DCD Section 3.6.2 Issues

KEPCO/KHNP

MEB Issue List for APR1400 DCD

Determination of Break Locations and Dynamic Effects Associated with the Postulated Rupture of Piping

- Issue #2

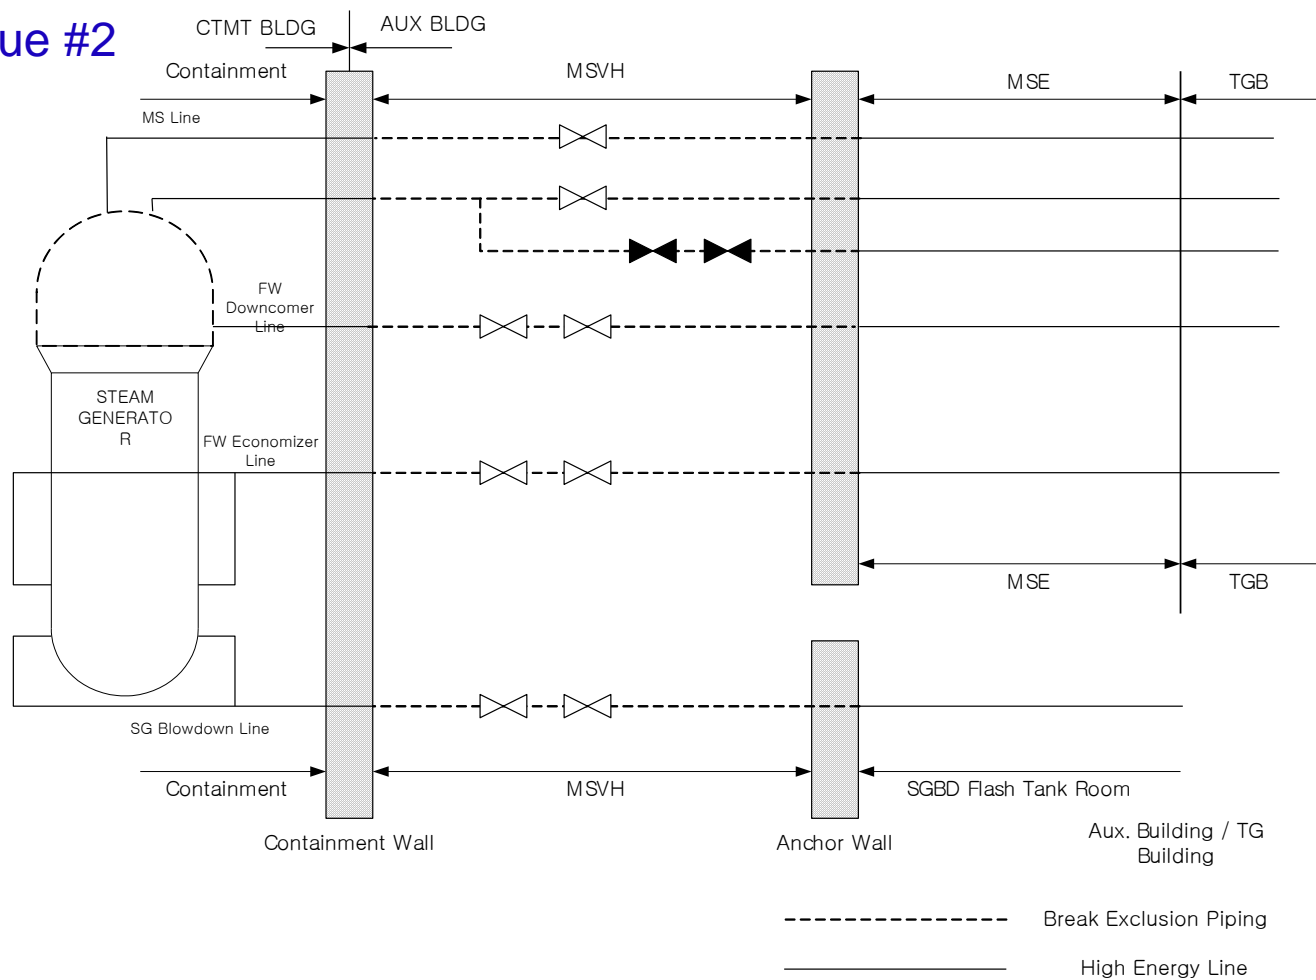
- DCD Tier 2, Subsection 3.6.2.1.4.3.2 states that cracks are not postulated in moderate-energy ASME Section Class 2 piping from the containment wall to and including the inboard or outboard isolation valves. This statement is consistent with the staff's guideline as described in BTP 3-4 Part B, Subsection A(ii). However, the break exclusion area for high-energy ASME Section Class 2 piping described in DCD Tier 2, Subsection 3.6.2.1.4.3.1 is between the containment penetration wall and auxiliary building anchor wall beyond isolation valves.

- For high-energy ASME Section Class 2 piping from the containment wall up to and including the inboard or outboard isolation valves, both pipe break and pipe cracks do not need to be postulated by meeting the ASME Section III, NE-1120. Pipe break exclusion expands to the auxiliary building anchor wall beyond the isolation valve by meeting additional requirements specified. DCD Section 3.6.2.1.4.3.1 will be revised for consistency with 3.6.2.1.4.3.2.
